2nd Further Information

**Proposed Temporary Warehouse (excluding Dangerous Goods Godown)
with Ancillary Facilities and Associated Filling of Land for Period of 3 Years in "Agriculture" Zone,
Lot 385 RP (Part) in D.D. 128 and Adjoining Government Land,
Ha Tsuen, Yuen Long, New Territories**

(S.16 Planning Application No. A/YL-HTF/1210)

Response-to-Comment (RtC)

Appendix I – Tree Survey Plan

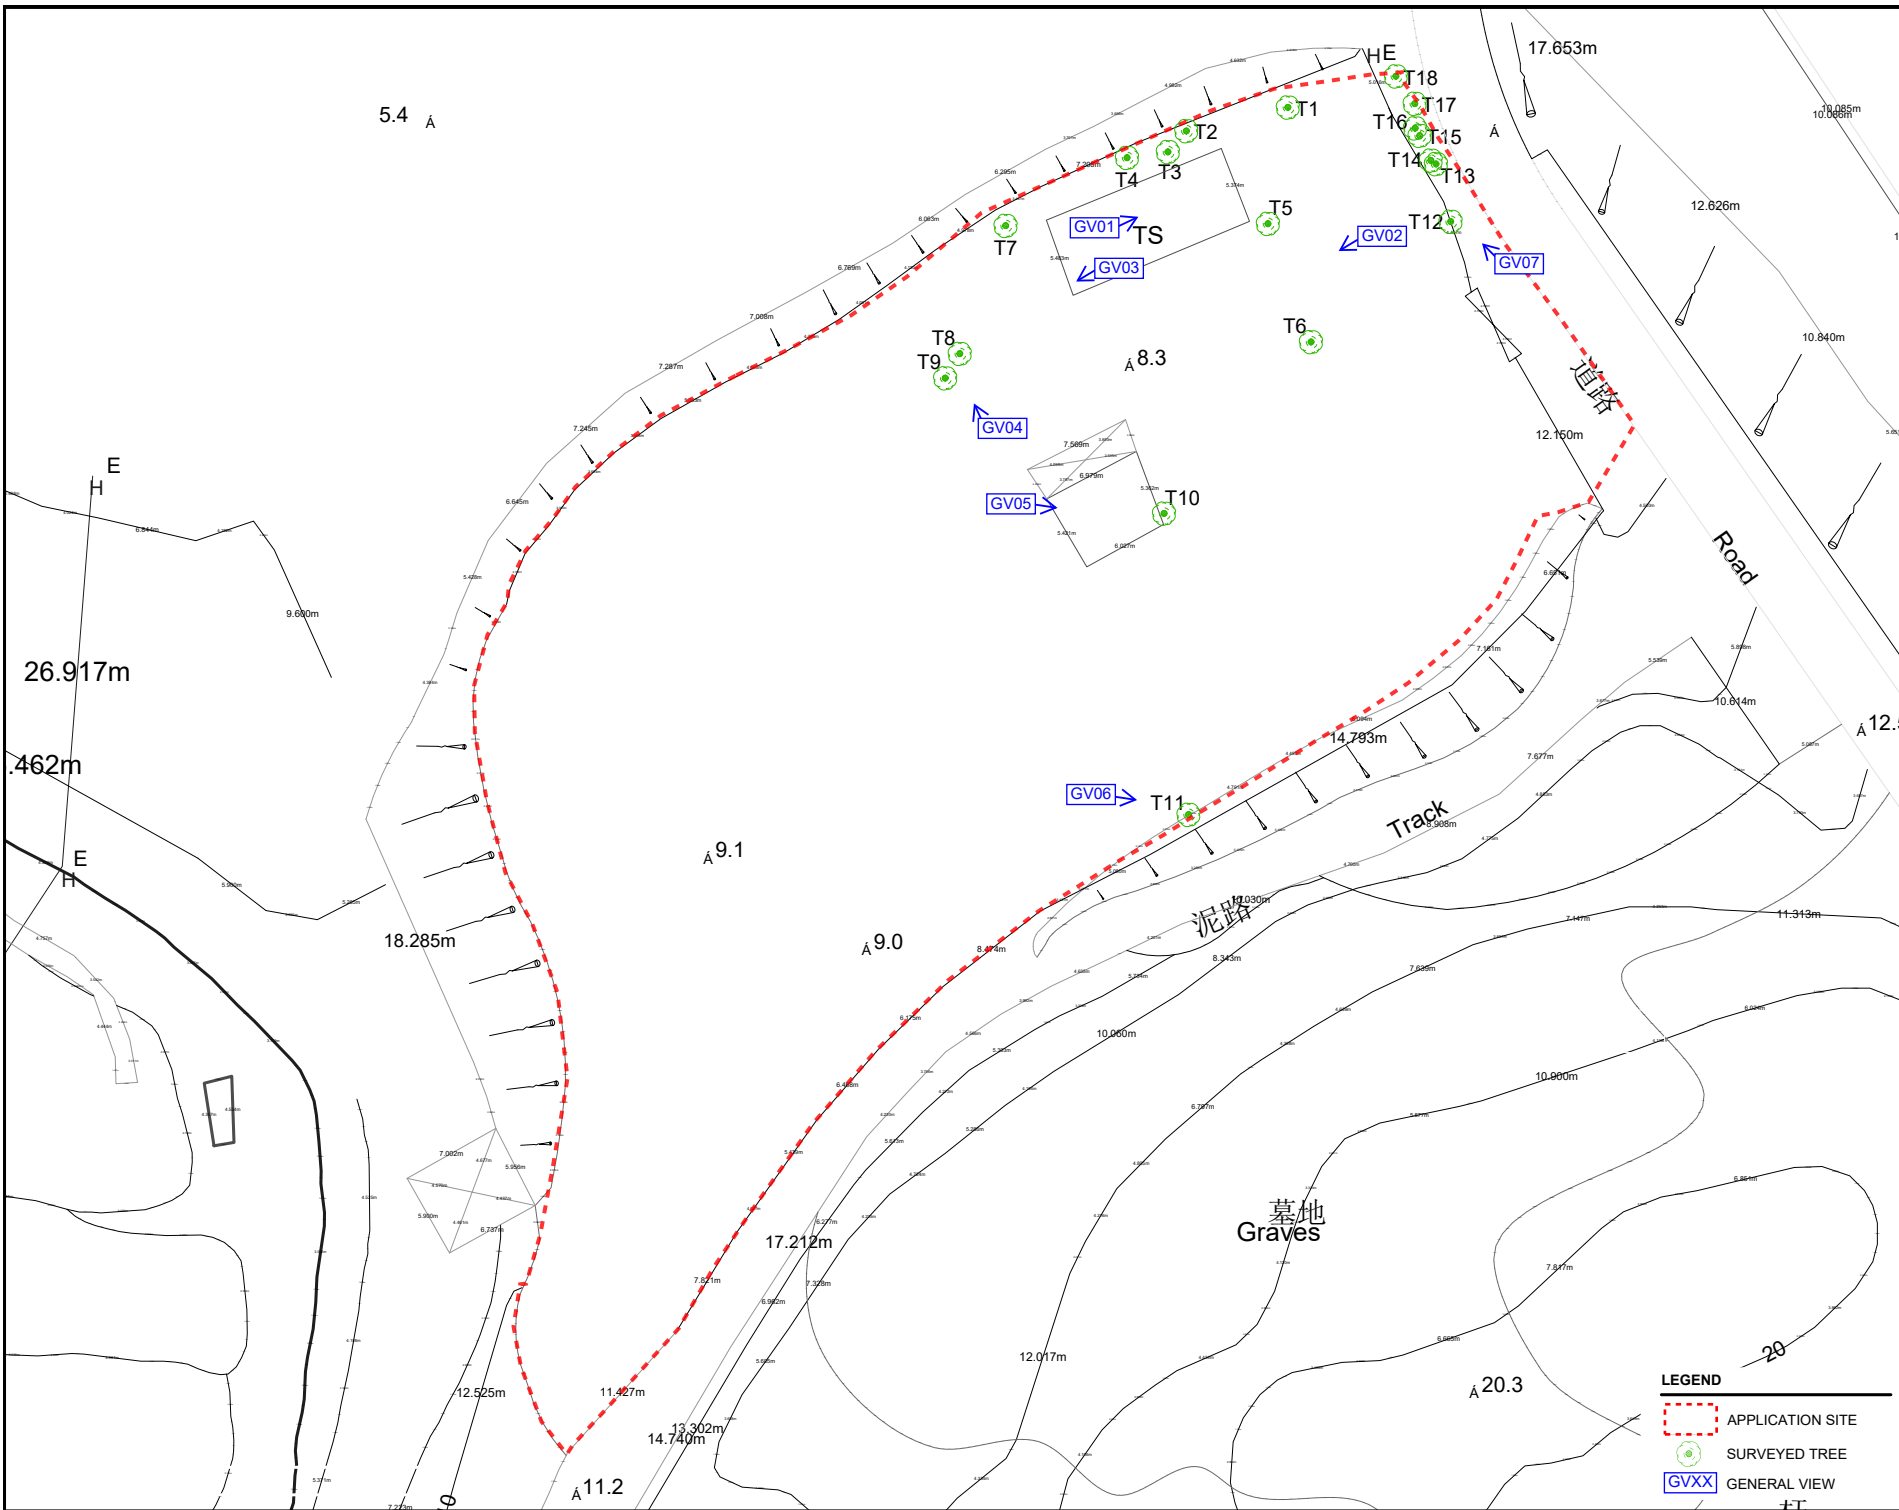
Departmental Comments		Applicant’s Responses
1. Comments of the Chief Town Planner/Urban Design and Landscape, Planning Department (CTP/UD&L, PlanD)		
(a)	<p>According to the submitted Planning Statement, no tree as defined under the Lands Administration Office Practice Note No. 6/2023 (i.e. trees with diameter-at breast height (DBH) ≥ 95 mm) was identified within the site boundary. As stated in the Application Form, no tree felling will be involved. However, based on the site photos in 2026, some trees of common species with DBH ≥ 95 mm were observed in the northeastern portion within the Site. With reference to the proposed Layout Plan, those trees with DBH ≥ 95mm may be affected.</p>	<p>The application site (the Site) was subject of a previous planning application No. A/YL-HTF/1179 submitted by the same applicant, which was approved by the Board in December 2024.</p> <p>15 nos. of existing tree and 3 nos. of dead tree within the application site were identified in the tree survey prepared for the previous planning permission. All trees identified therewithin were of common species. Among them, 6 of them are in direct conflict with the proposed development and are proposed to be felled. Besides, 3 dead trees will be removed. The remaining 9 trees will be retained in situ.</p> <p>In order to mitigate the potential landscape impact arising from the proposed development, the applicant proposes to plant 9 nos. of new tree on a 1:1 ratio, with a view to compensating for the 6 nos. of existing tree to be felled, and 3 nos. of dead tree to be removed.</p> <p>The tree survey and landscape plan at Annex 1 refer.</p>

At the time of inspection on 15th October 2024, **18 nos.** tree were found within the Site. **3** dead trees (T14, T15, and T16) were recorded in the surveyed area. Location of individual tree refers to Appendix I.
